N5182B-09

Modification Available Performance Enhancement Service Note

N5182B X-Series MXG Vector Signal Generator

The Problem - Self-Test 401 False Failures with Firmware Versions older than B.01.41

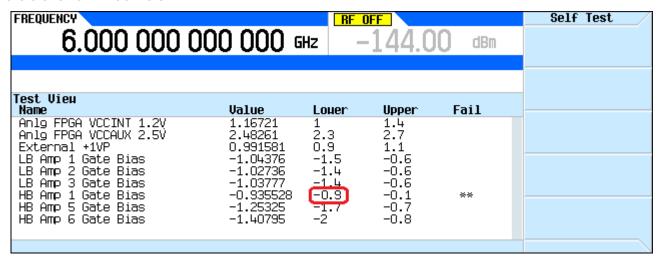
With the release of firmware versions B.01.41 the lower limit for the High Band Amplifier 1 Gate Bias test, which is part of Self-Test 401, was changed from -0.9 to -1.3.

Instruments that are failing this part of Self-Test 401 with the older firmware version could possibly pass the same Self-Test after a newer version of the instrument firmware is installed.

To see what Self-Test limits are being used press **Utility**, **Instrument Info**, **Self Test**, **View Test Info**. Then scroll down to highlight test **401** and press **View Details**. If there are no details available press **Return**, **Run Highlighted** to run that Self-Test, then press **View Details** again. The image below shows the old lower limit of -0.9

Instruments failing the lower limit of Self-Test 401 for the High Band Amplifier 1 Gate Bias test, as shown in the figure above, that have a firmware version older than B.01.41 should be updated with the latest instrument firmware version.
